Re: FortisBC Inc. (FBC)

2021 Long-Term Electric Resource Plan (LTERP) and Long-Term Demand-Side Management Plan (LT DSM Plan) (Application)

Response to the Commercial Energy Consumers Association of British Columbia (CEC) Information Request (IR) No. 1

Figure ES-1: Gross Energy Load Forecast (GWh)

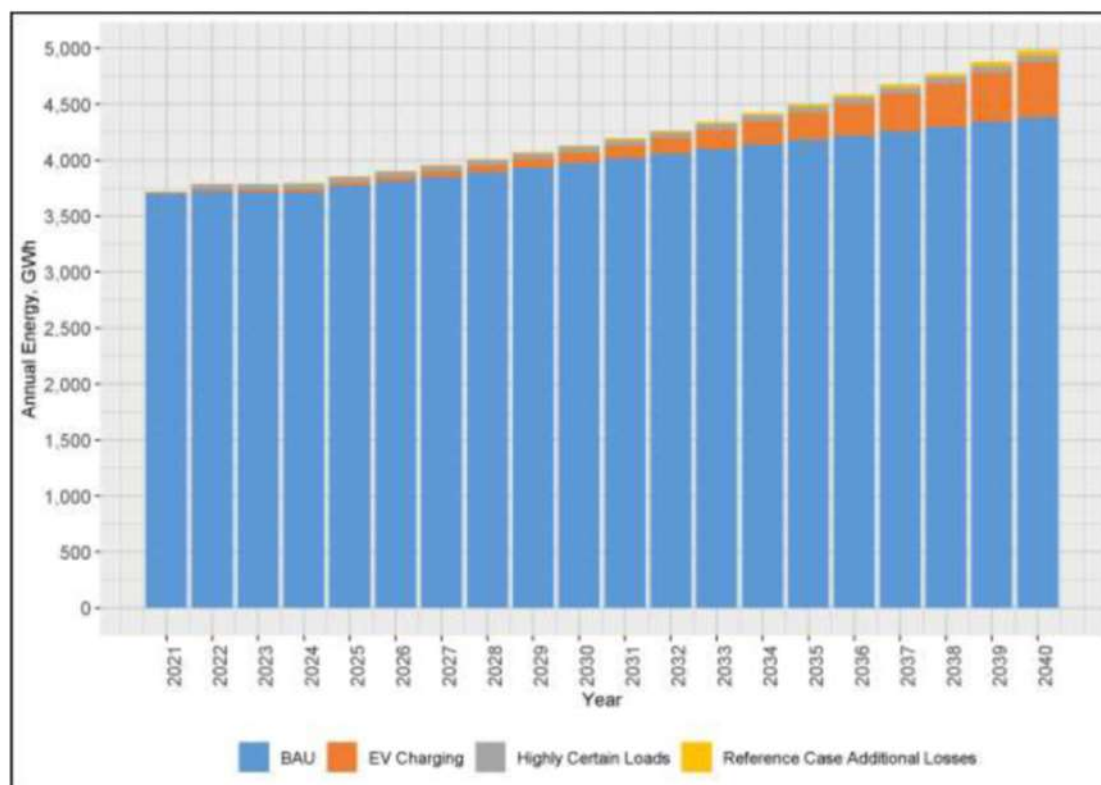
1.1 Please provide the expected introduction of net metering solar energy reduction of loads expected over the same time period, including the potential for solar-based charging for vehicles as the cost of solar energy capture and use becomes increasingly competitive between now and 2040, and provide FBC's assumptions with respect to solar displacement of loads and load growth.

FBC has not assumed any material incremental energy reduction of loads due to net metering solar energy or the potential for solar-based charging for vehicles in its BAU or Reference Case load forecast. As discussed in Section 2.3.4, the estimated annual energy generation is currently about 6 GWh per year, or less than 0.2 percent of FBC's total annual energy requirement in 2020. This current level of generation is already captured in the BAU and Reference Case load forecasts as it is intrinsic in the historical load data.

Figure ES-4: Load Scenarios' Annual Energy Impacts

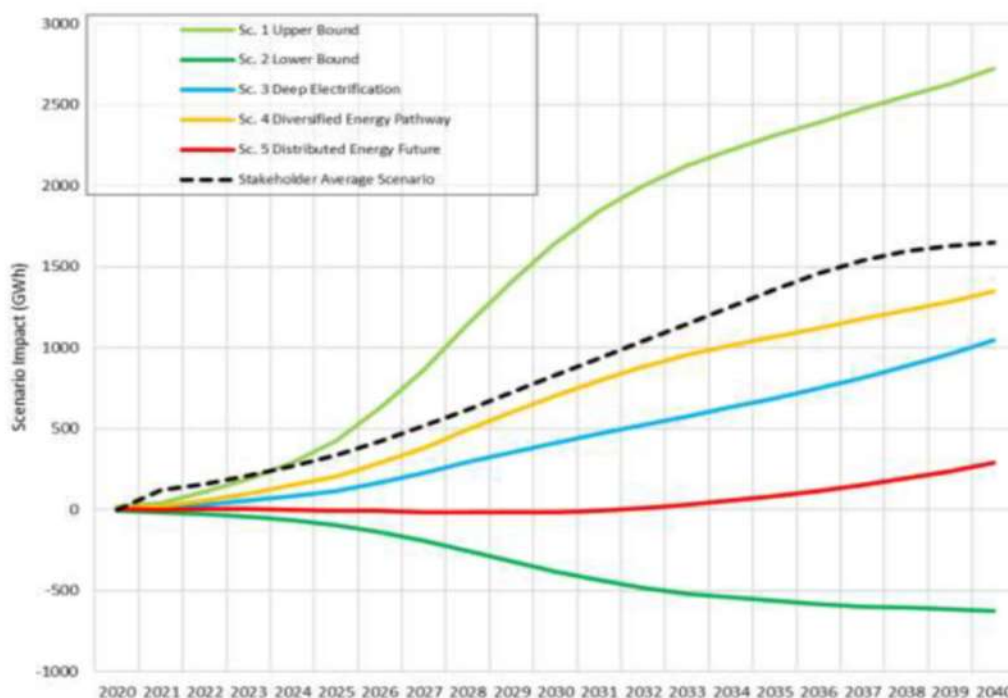
2.1 Please provide FBC's probability estimate for: (a) a Distributed Energy Future; (b) a Diversified Energy Pathway; and (c) a Deep Electrification future.

6 **Figure 2-5: Light-duty EV Sales as a Percent of Total Light-duty Vehicle Sales⁶⁰**

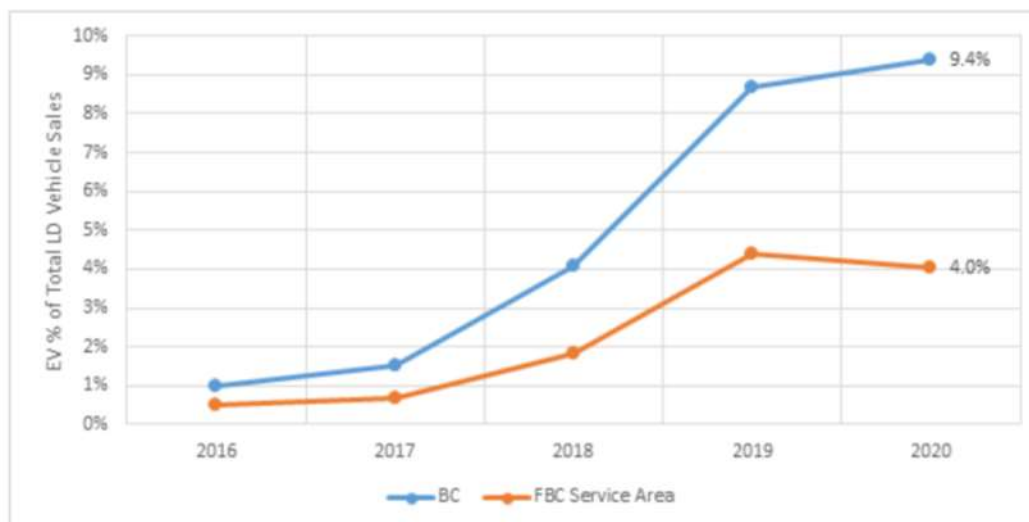
4 11.1 Please comment on whether or not the pandemic uncertainties have persisted
5 through into 2021 and provide the evidence available to define the degree of
6 rebound given the levels of vaccine protection being reached in the community
7 and the pending confidence in a return to some version of normalcy.

Figure 2-16: Comparison of Sumas Price Forecasts and Forward Prices

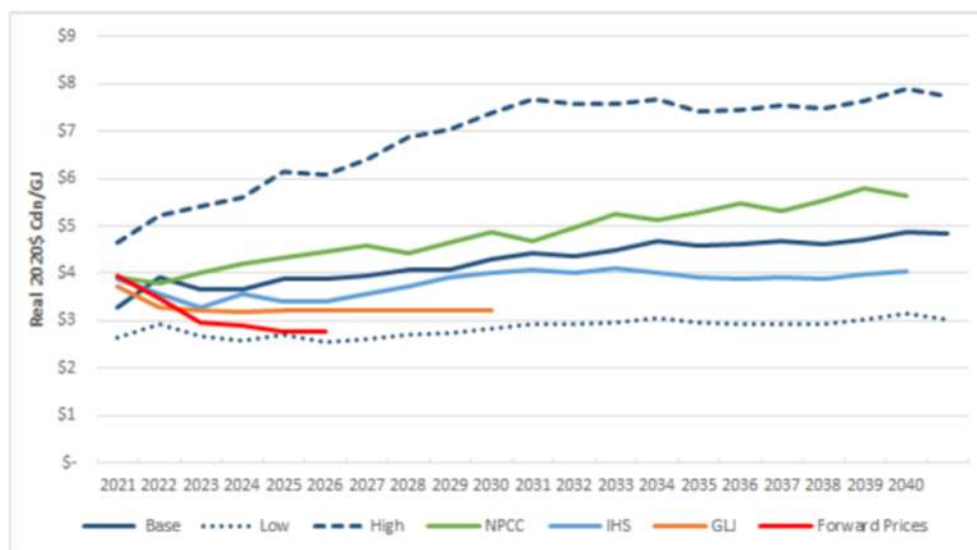
20.1 Please provide historical forecasts from these same sources over the last 10 years and juxtapose those to the subsequent reality in the energy markets.

The actual prices from 2018 to 2021 have settled higher than the most recent IHS price forecasts mainly due to pipeline infrastructure constraints causing prices to settle higher during peak demand periods and cold weather events that occurred in the 2019/20 and 2020/21 winter

1 **Figure 2-18: Mid-C Electricity Annual Price Forecasts**

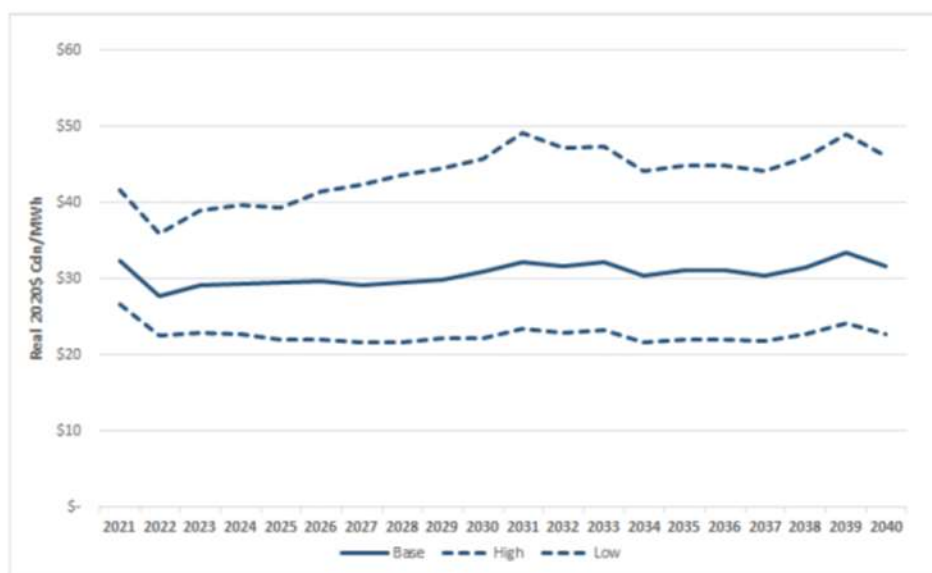
21.1 Please provide past forecast from the same source for the last 10 years and juxtapose those to the actual data of each year to enable an understanding of the forecasting accuracy.

The figure below includes the addition of historical price forecasts available to FBC over the last ten years. The figure includes additional price forecasts from NPCC (2016 Forecast), IHS (2018 Forecast) and the settled prices at the Mid-C market. All prices are in real 2020 dollars. The settled market prices have fluctuated significantly over the past 10 years in response to various market supply and demand dynamics. The NPCC 2016 price forecast average of \$49.40 per MWh is much higher than the settled price average of \$35.02 per MWh and the base price forecast average of \$35.98 per MWh, due to tighter supply and demand balances at the time of that forecast. The later IHS 2018 price forecast trends lower than actual settled prices and the base price forecast for the first few years and then trends steeply upwards, increasing above the base price forecast after 2024.

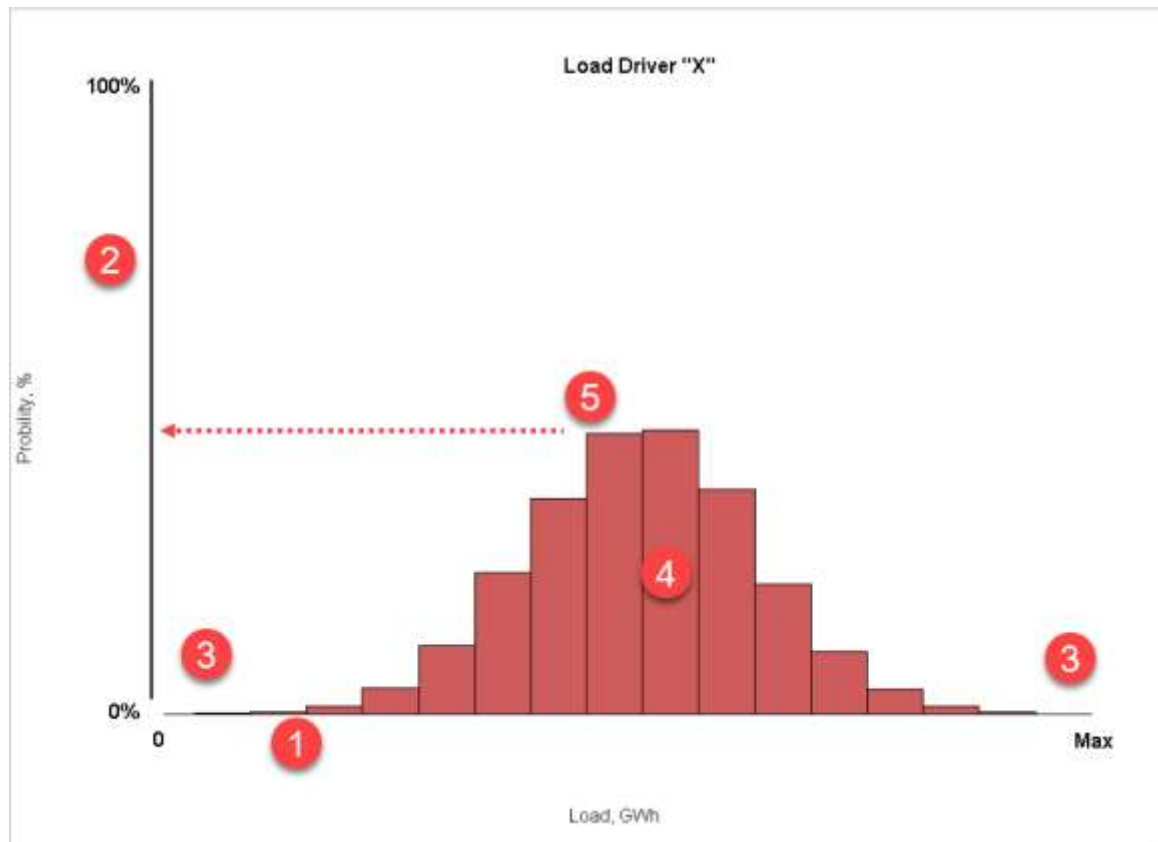
26.1 Please confirm that there would be significant uncertainty in any load forecast which falls within the upper and lower bands of a forecast.

Figure 7-1: Annual Energy Load-Resource Balance (GWh)

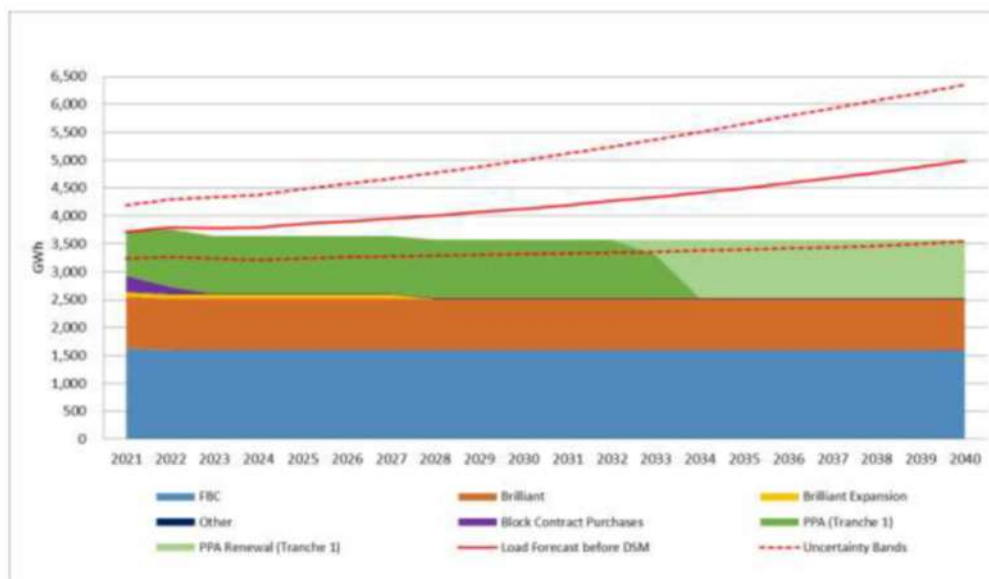
36.1 Please provide the market purchase capability graphically (and with the data) throughout the year, which FBC has been able to access in the past and provide the market availability for purchases in regard to the FBC capability to purchase.

Note that FBC cannot currently purchase 3,241 GWh annually from the market due to the following non-exhaustive list of reasons: commitments to existing supply-side resources, contractual limitations, and insufficient customer load.

Figure 9-1: Energy Load-Resource Balance after DSM

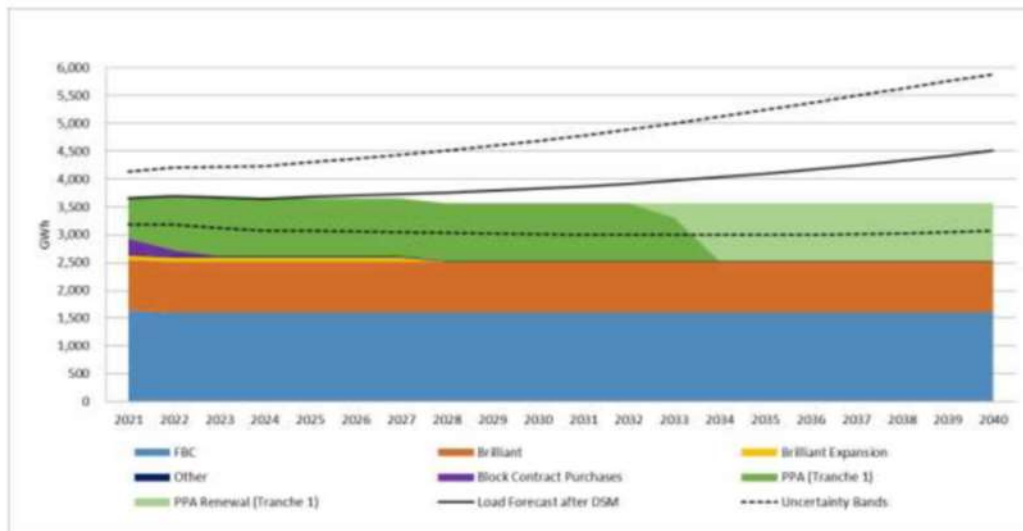
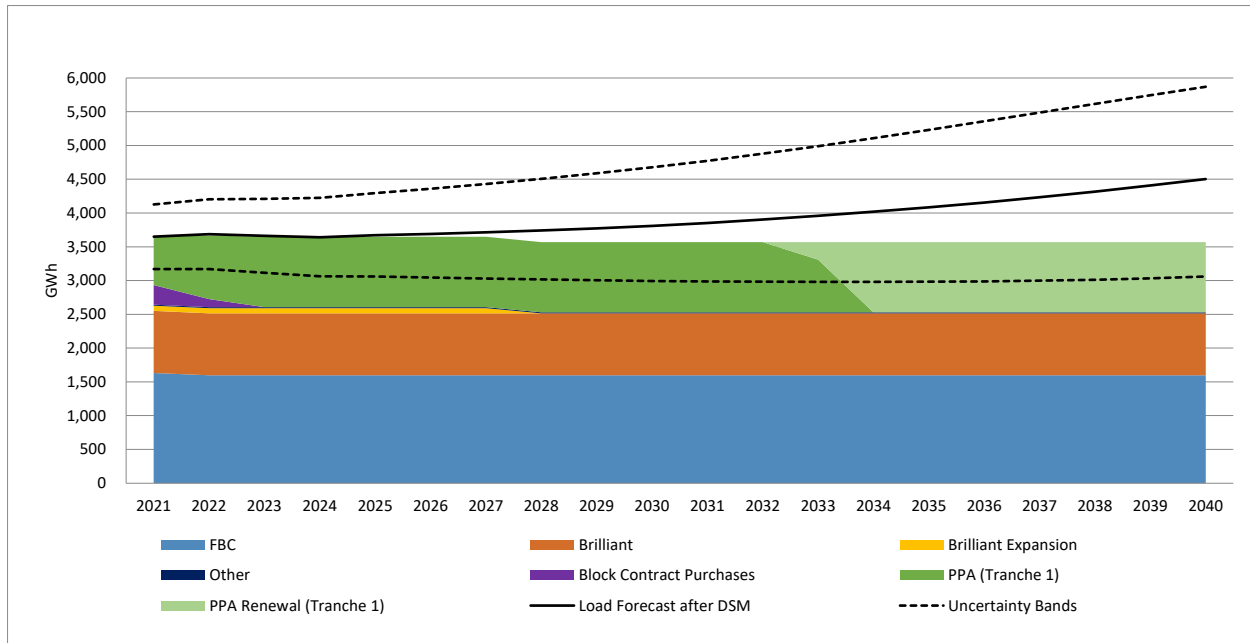
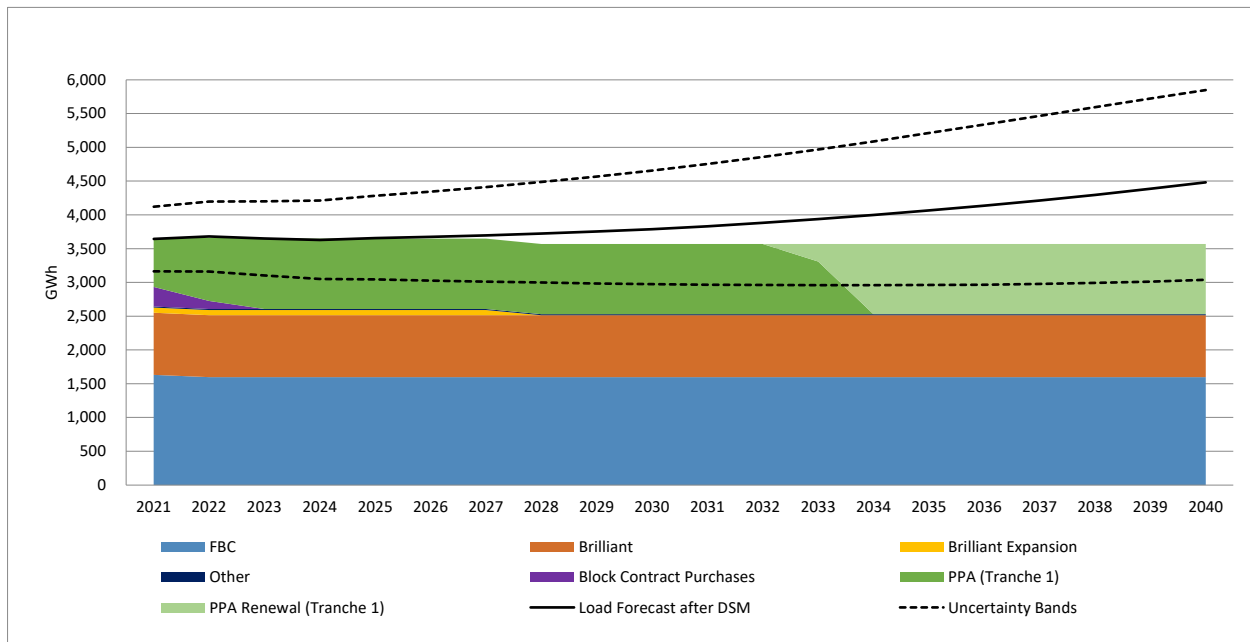
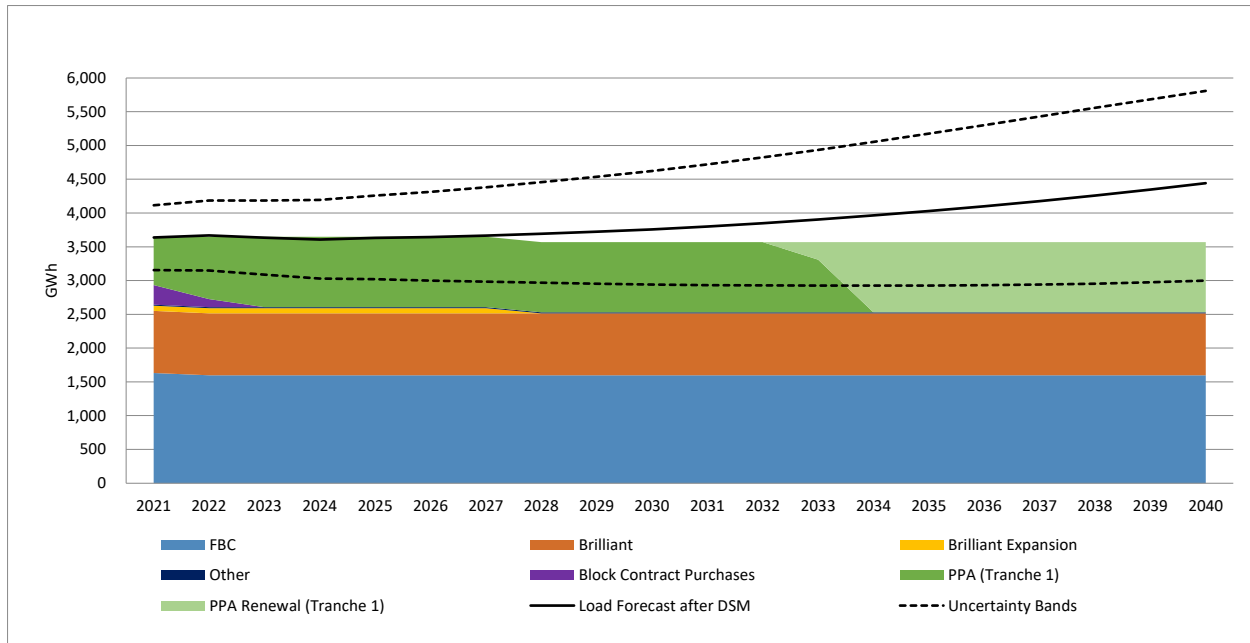
41.1 Please provide an Energy Load Resource Balance (“E-LRB”) graphically as in Figure 9-1 for each of the alternative DSM options with higher incentives.
